Northern Contra Costa County
Feasibility Level Desalination
Facility Cost

Delta Diablo Sanitation District

April 2005

Appendix E. Resolution of Comments

Figure ES-1: Reverse Osmosis Process

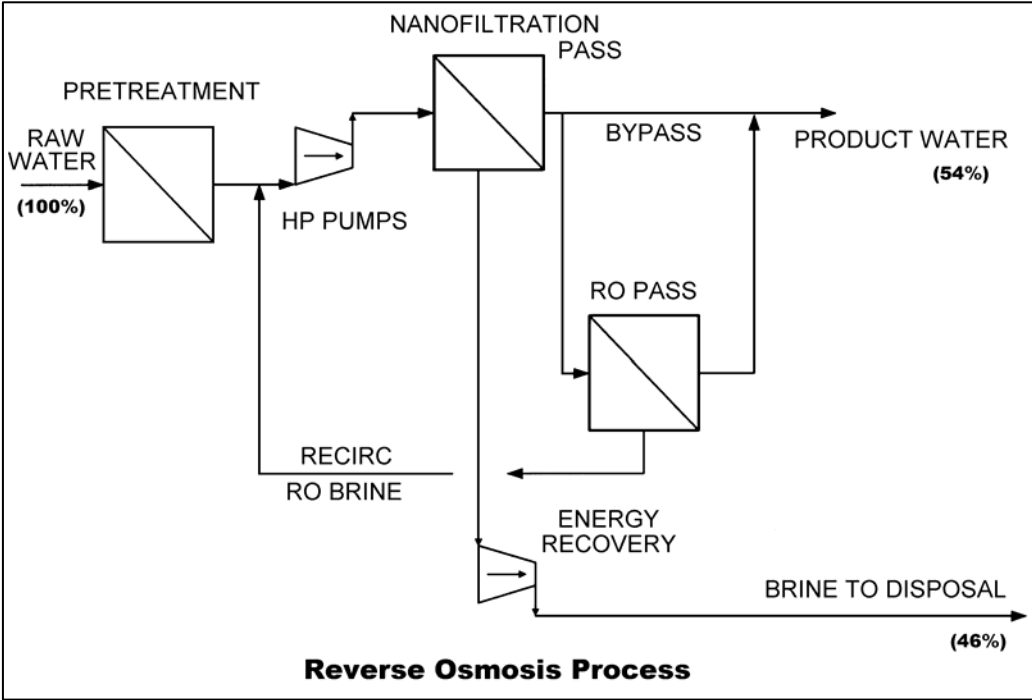
- Costs for pretreatment are included. Disinfection costs were not included as these should be the same as for any competing source of water.
2. There are a few questions on the schematic shown on the RO process - is it correct to show energy recovery that discharges to brine disposal?, or on the second pass RO option, to show 100% recirculation without a bypass to brine?

Figure 1-2: Discharged Brine TDS

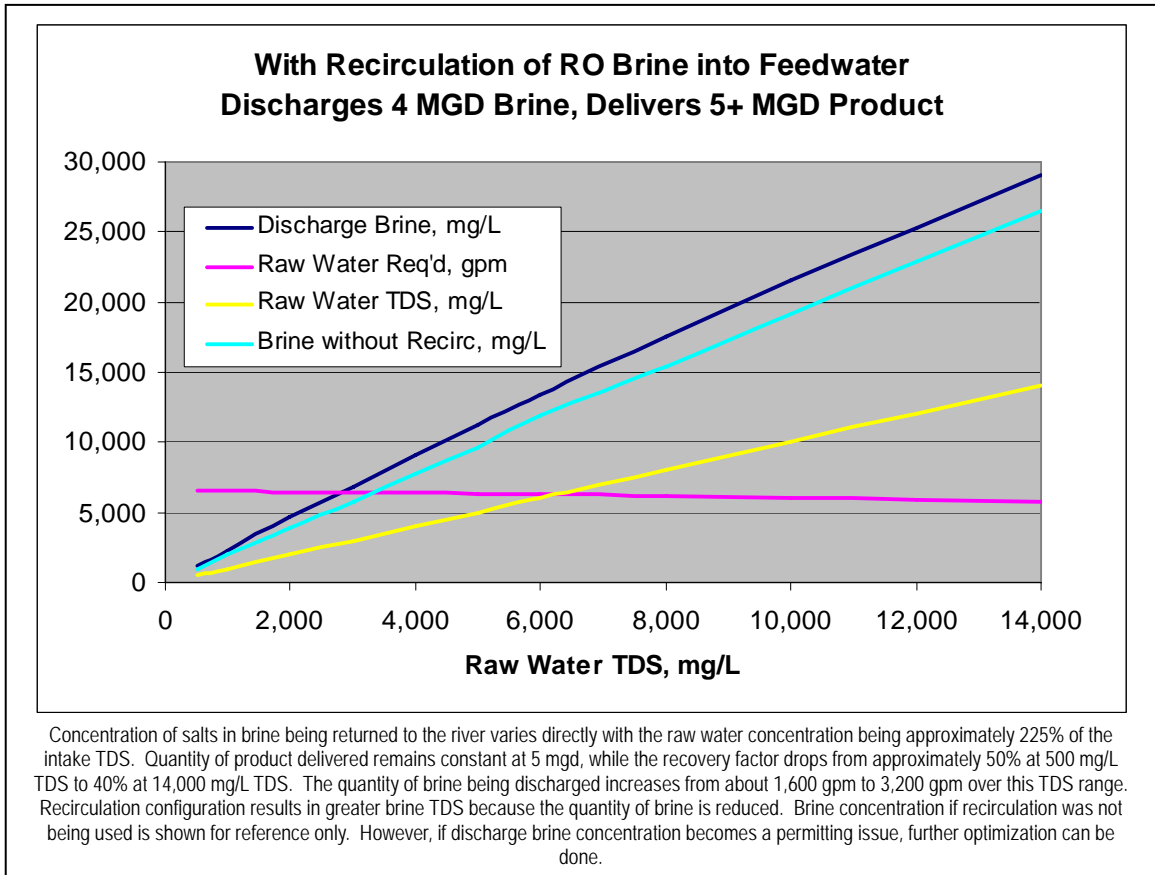
2. Page 5, Figure 2. Confusing graph.
 - The purpose of the chart is to show discharge Brine TDS as a function of Raw Water TDS, and to give some insight to the process. The process is much more complex than the chart suggests.

Figure 1-4: Annual Electricity Expense

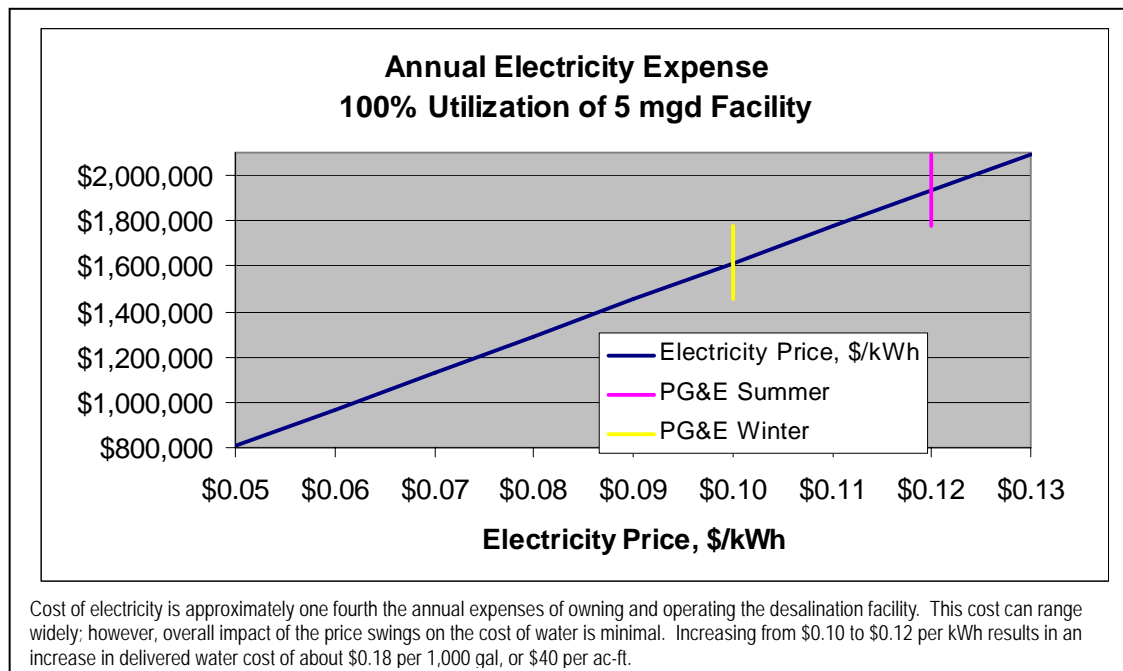
- Table 1-5 shows cost of water in both \$/af and \$/1,000 gal. Figure 1-3 shows how the unit cost of water varies as a function of utilization.
6. Page 10, Figure 4. Cost of electricity is usually cited as 1/3, not 1/4 of the cost of a desalination facility (see Table 6 on page 14). Does this assume a special rate for the electricity used at this facility? If so, the report should state that.
